**ZONING CHANGE REVIEW SHEET**

CASE: C14-2019-0129 – 10801 Wayne Riddell Loop      DISTRICT: 5

**Date:** February 13, 2020  
**To:** Wendy Rhoades, Case Manager  
**CC:** Dan Hennessey, P.E.  
Curtis Beatty, P.E.  
Amber Mitchell  
Joan Jenkins, EIT  
**Reference:** South 1<sup>st</sup> Street Apartments – TIA Final Memo (C14-2019-0129)

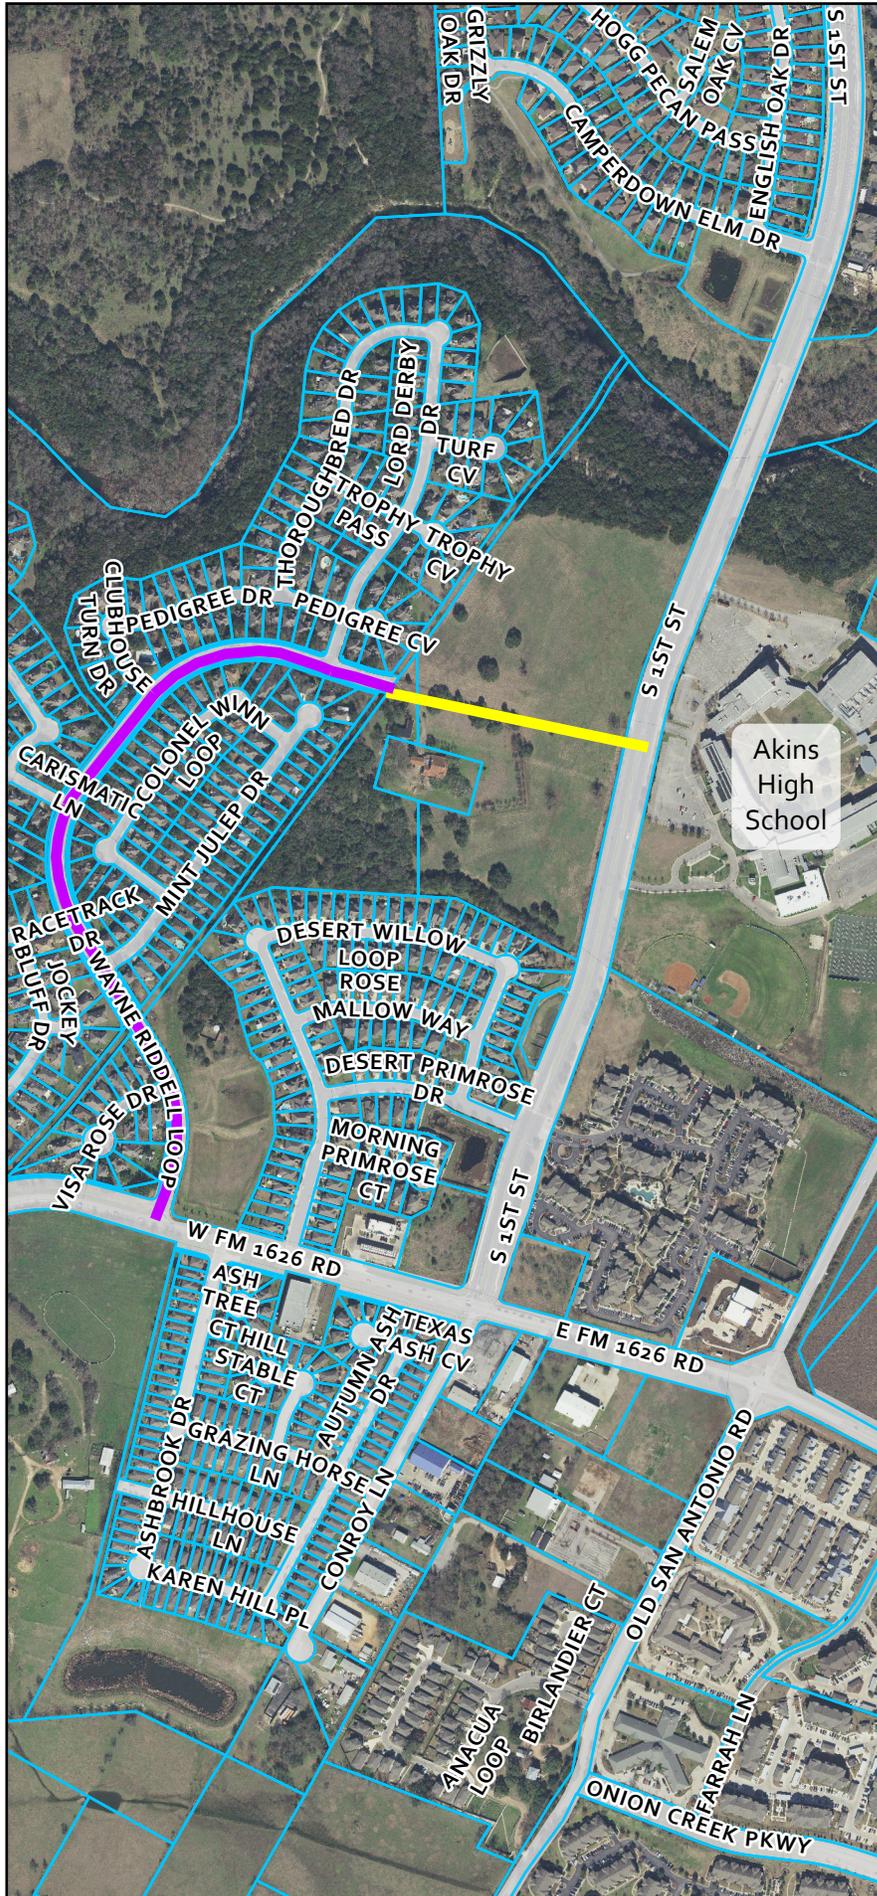
The applicant shall dedicate 68' of ROW across the property to accommodate the extension of Wayne Riddell Loop as shown in the Austin Strategic Mobility Plan (ASMP). In addition, the applicant shall design and construct the Wayne Riddell Loop extension from its current terminus to South 1<sup>st</sup> Street. The design intent is for a full three-lane cross-section from South 1<sup>st</sup> Street to the project driveways, after which the cross-section shall taper to match the existing Wayne Riddell Loop cross-section. The proposed cross-section shall consist of two 5-ft sidewalks, two 2-ft buffer zones, two 7-ft bike lanes with 2-ft buffers, and three 12-ft lanes, for a total width of 68'. Two 2-ft easements will be required on either side for sidewalk maintenance. Coordination with applicable City departments shall be required for the design of the extension.

To improve bicycle safety and connectivity near the project site, the applicant shall upgrade the existing buffered bike lanes to delineator-separated protected bike lanes on both sides of South 1<sup>st</sup> Street adjacent to the property. As mitigation for this development, the applicant shall also make a \$55,500 fee in-lieu payment to the City to provide sidewalk connection from the south property line to the existing sidewalk north of Desert Primrose Drive.
